# Video Products Technical Bulletin 30-2017-021

SUBJECT: **PARTS INFORMATION—CN6401 ON OLED MODULE AND QBC BOARD**

MODEL: **PVM-A170**  
*PVM-A170*  
**PVM-A250**  
*PVM-A250*

**Figure 1**

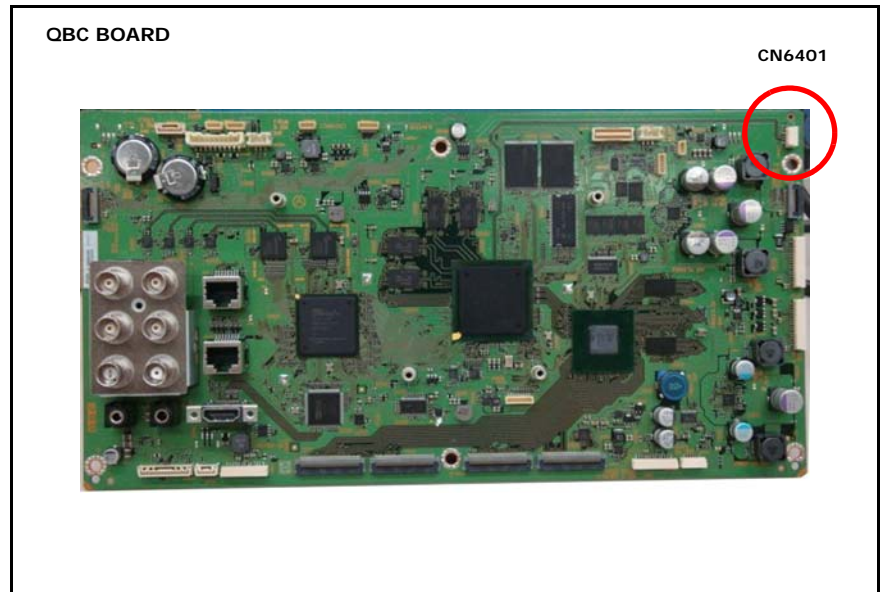
CN6401 (4-pin connector) is removed from the OLED module assemblies and QBC boards supplied as service parts. (See Table 1 and Figure 1.)

When using the service parts for a monitor that has the connector assembly, which connects the QBC (CN6401) and the H2 boards (CN004), leave the assembly unconnected.
